ALPINE CITY COUNCIL MEETING AGENDA

NOTICE is hereby given that the CITY COUNCIL of Alpine City, Utah will hold a meeting on **Tuesday, March 10, 2015 at 7:00 pm** at Alpine City Hall, 20 North Main, Alpine, Utah as follows:

- B. **Eagle Point PRD Preliminary Plan Exceptions Review – Mark Wells and Taylor Smith – Approximately 800 W 600 N:** The City Council will make determinations on requested exceptions for the Eagle Point PRD for the final plan.

SUBJECT: Eagle Pointe PRD Preliminary Site Plan

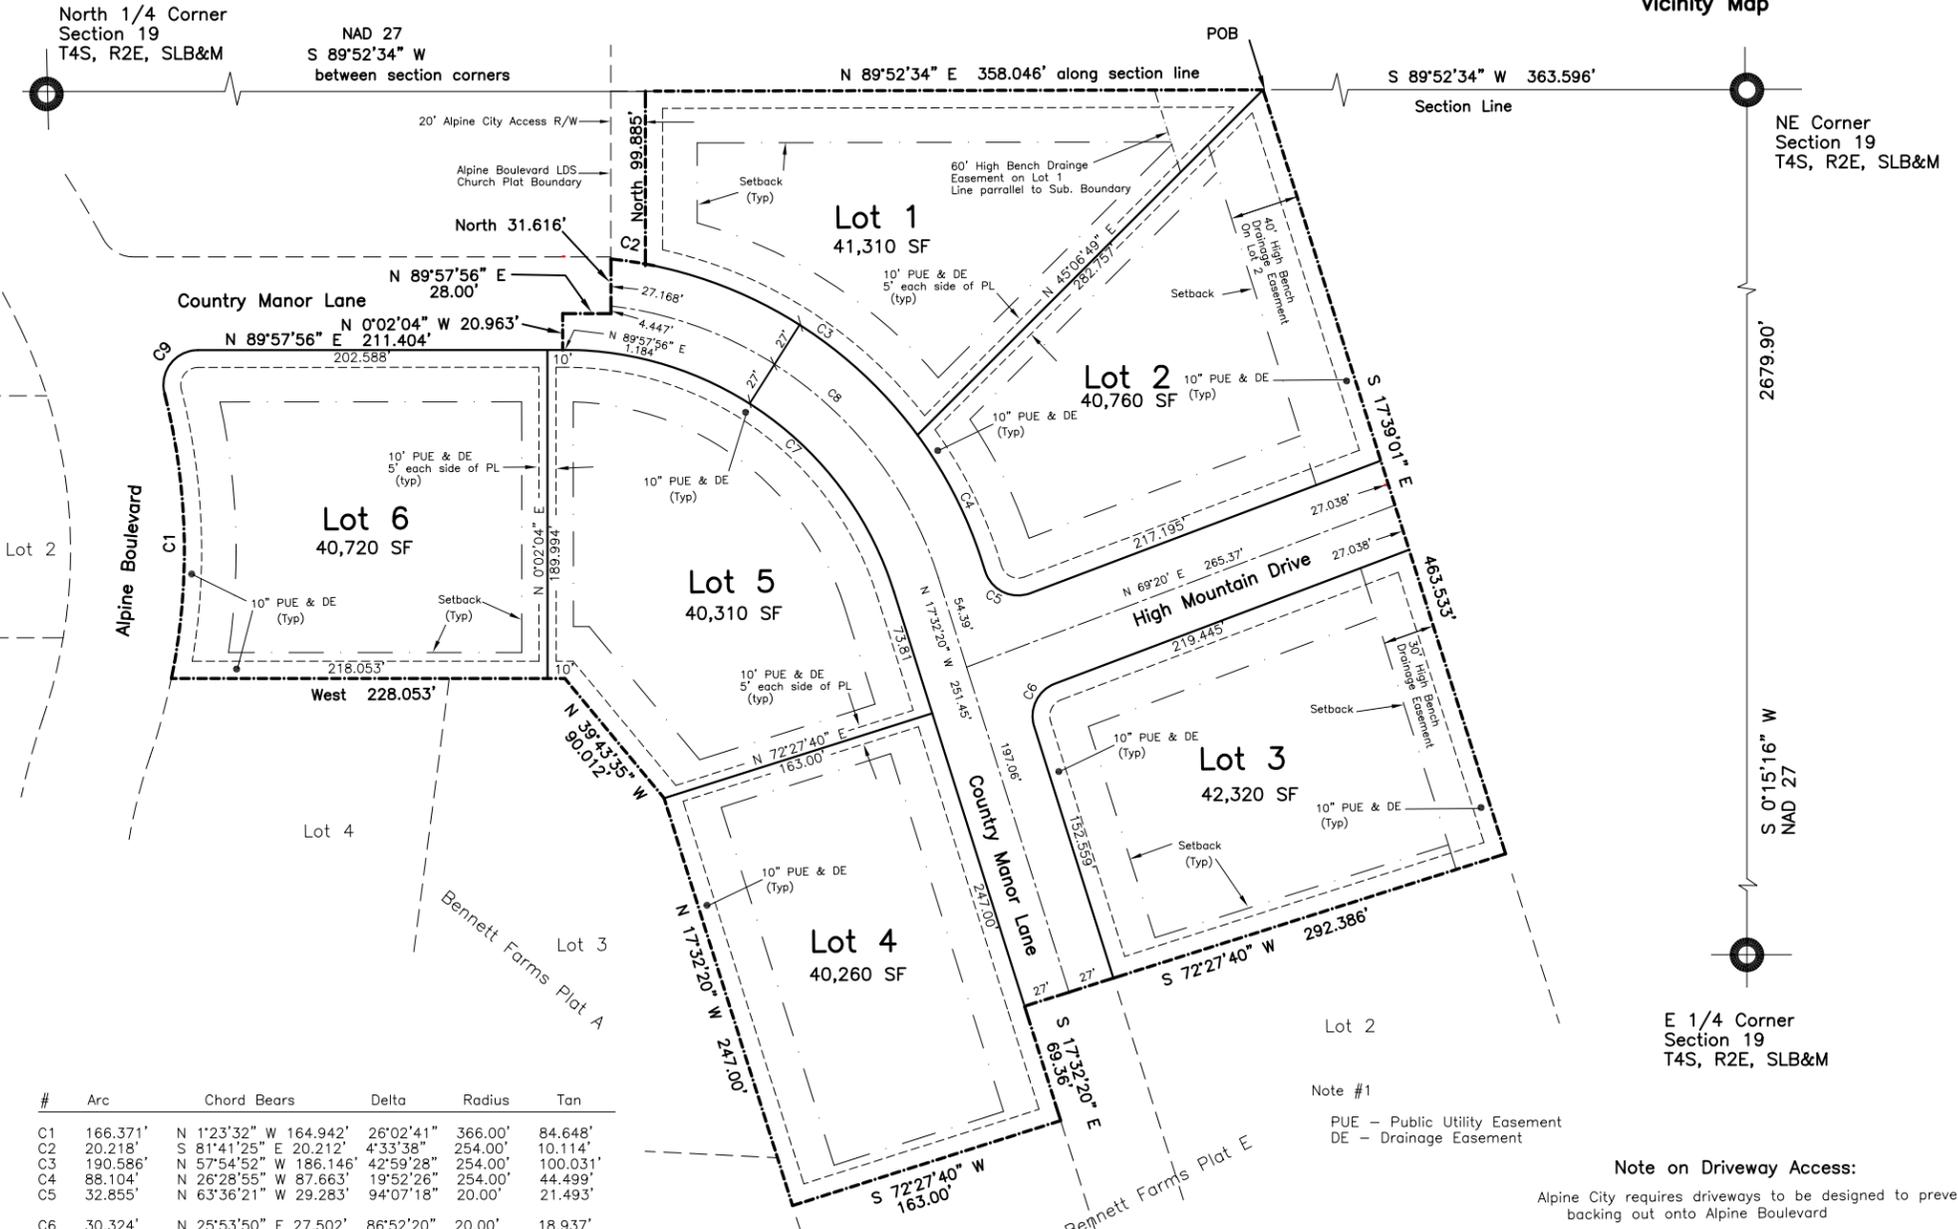
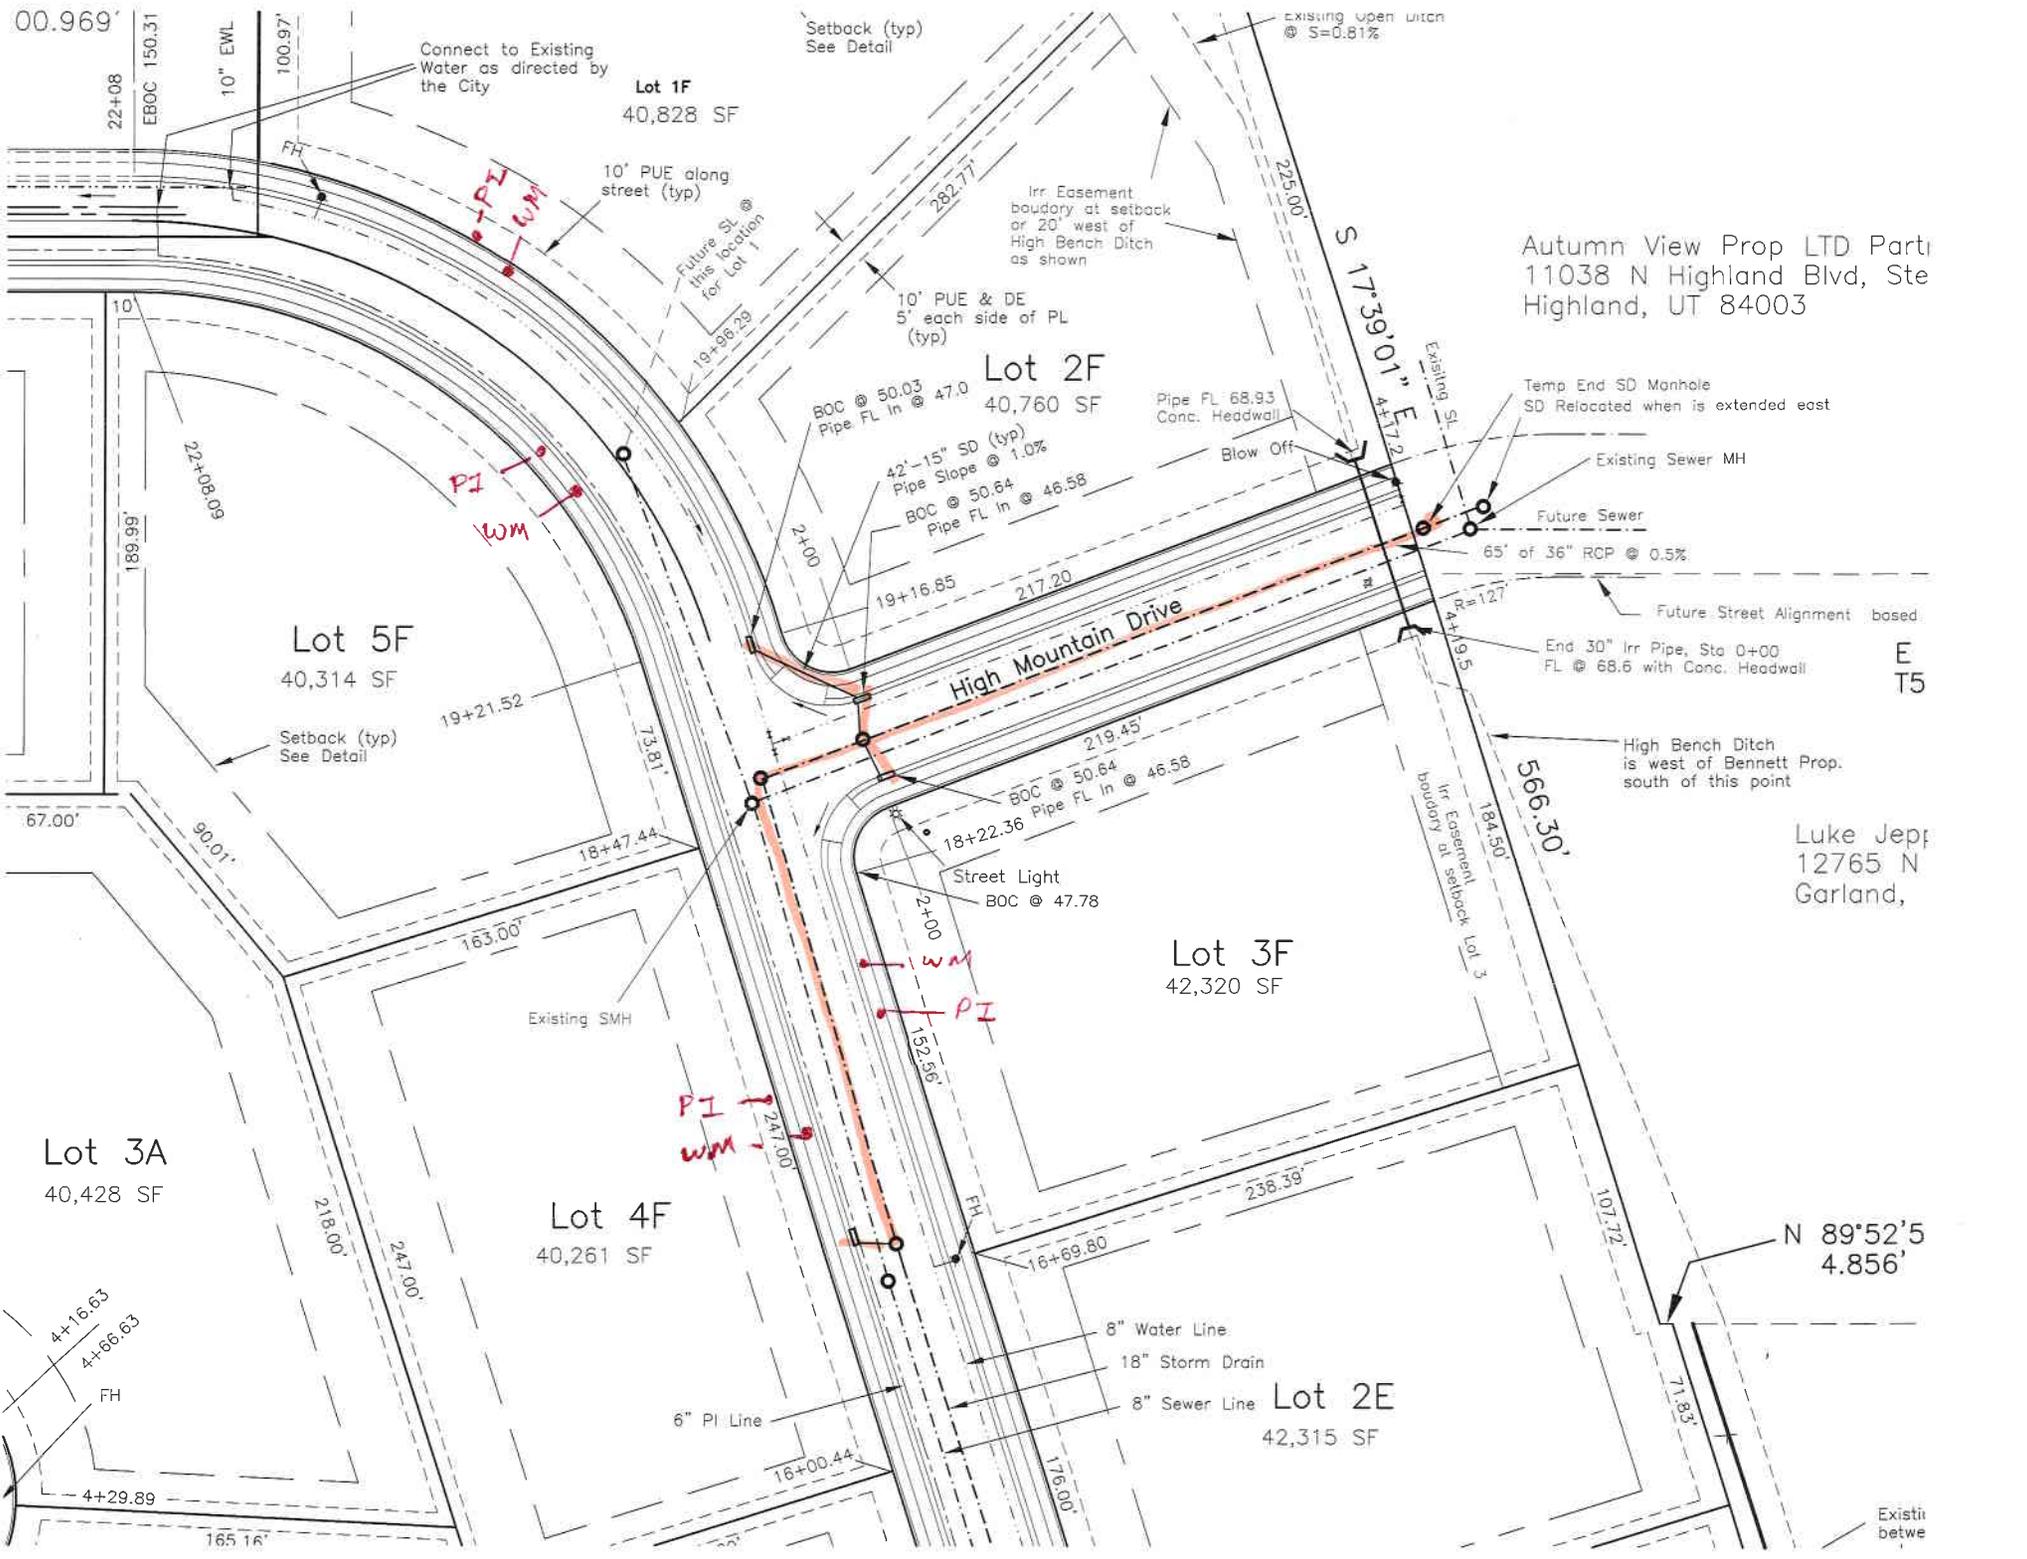
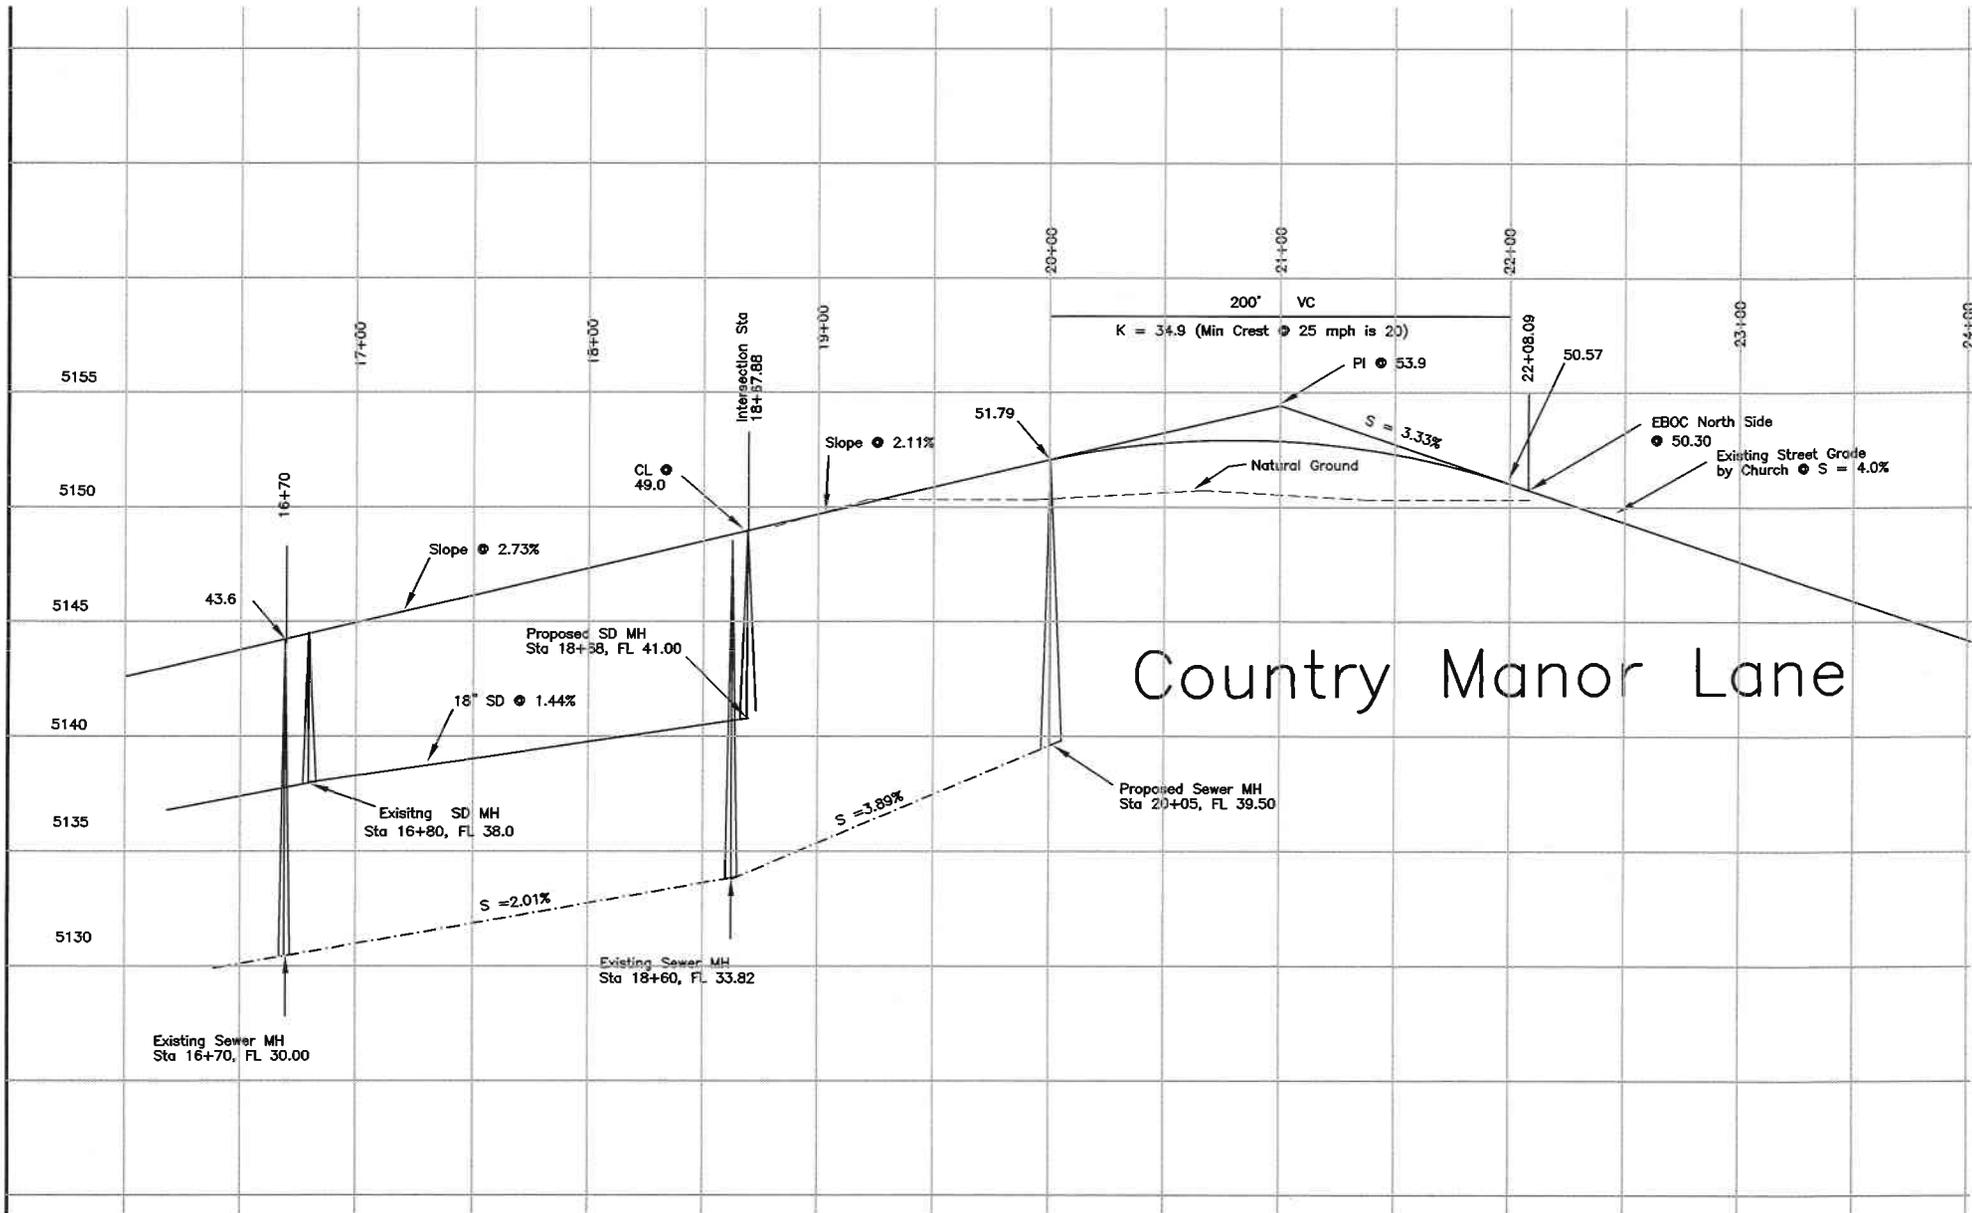
The proposed development shows extending Country Manor Lane to provide the required frontage for the lots. This phase extends and completes the northern end of Country Manor Lane by connection to Alpine Boulevard. A stub street is provided for future development of lots to the east named High Mountain Drive. Plan and profiles have been submitted for the streets and are approved. Curb, gutter and sidewalk are shown to be constructed and extended from where the current road ends through to Alpine Boulevard on both sides of the road.

There is an existing 8-inch sewer line in Country Manor Lane that will be extended to serve the additional lots. Sewer has also been stubbed eastward for future development. A 4-inch lateral will be required for each lot and is shown on the plans.

The plans show storm water being collected via catch basins and transported south via a piped system. A detention basin was appropriately sized and built to handle the capacity in an earlier phase of Bennett Farms. The drainage from this phase of development drains to this basin. The storm drain will be stubbed to the end of High Mountain Drive for future development.
